V2500-A5 SERIES PROPULSION SYSTEM SERVICE BULLETIN

This document transmits the Revision 3 of Service Bulletin V2500-ENG-73-0208.

V2500-ENG-73-0208

ENGINE – FUEL AND CONTROL – PROVIDE A NEW ELECTRONIC ENGINE CONTROL (EEC) WITH A5
SCN20A/Z SOFTWARE

FAMILY TREE - ELECTRONIC ENGINE CONTROL (EEC) REF. CATALOG SEQUENCE NO. 73-22-34.
 FIG. 01 ITEM 280 - FOR V2500-A5 DELIVERED ENGINES
 CHART A (SHEET 1 OF 4)

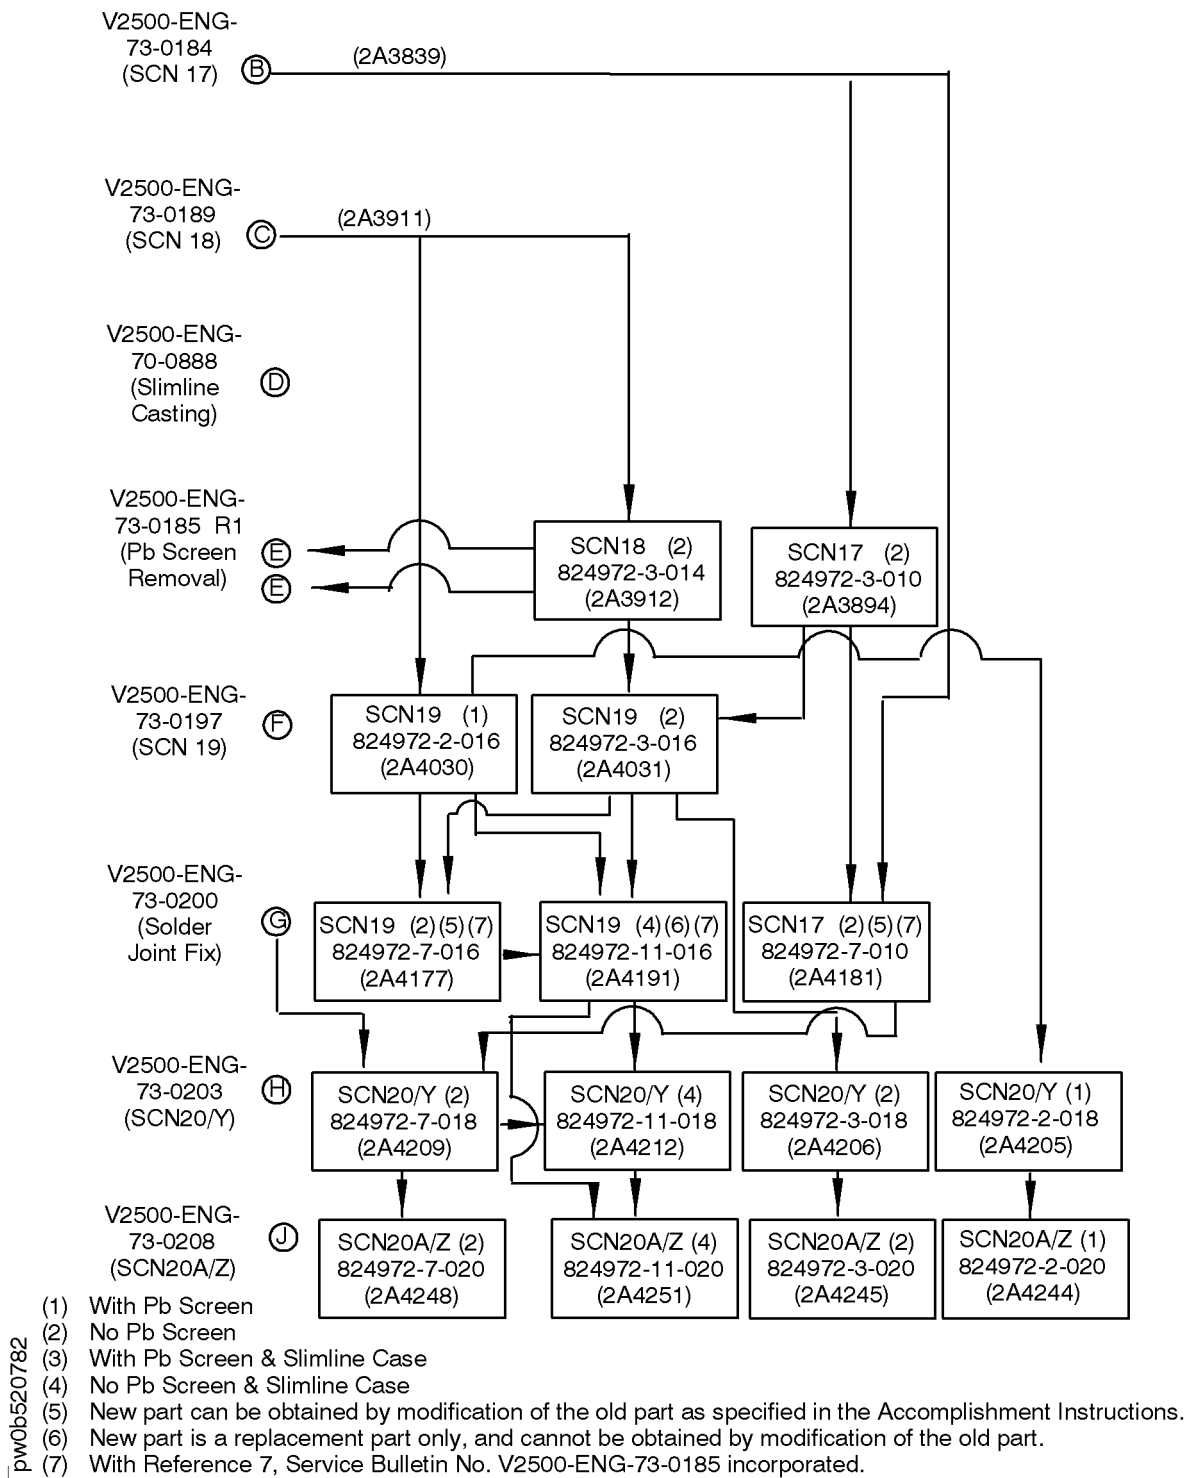
- (1) With Pb Screen
 (2) No Pb Screen
 (3) With Pb Screen & Slimline Case
 (4) No Pb Screen & Slimline Case
 (5) The new part can be obtained by modification of the old part as specified in the Accomplishment Instructions.
 (6) The new part is a replacement part only, and cannot be obtained by modification of the old part.
 (7) With Reference 7, Service Bulletin No. V2500-ENG-73-0185 incorporated.
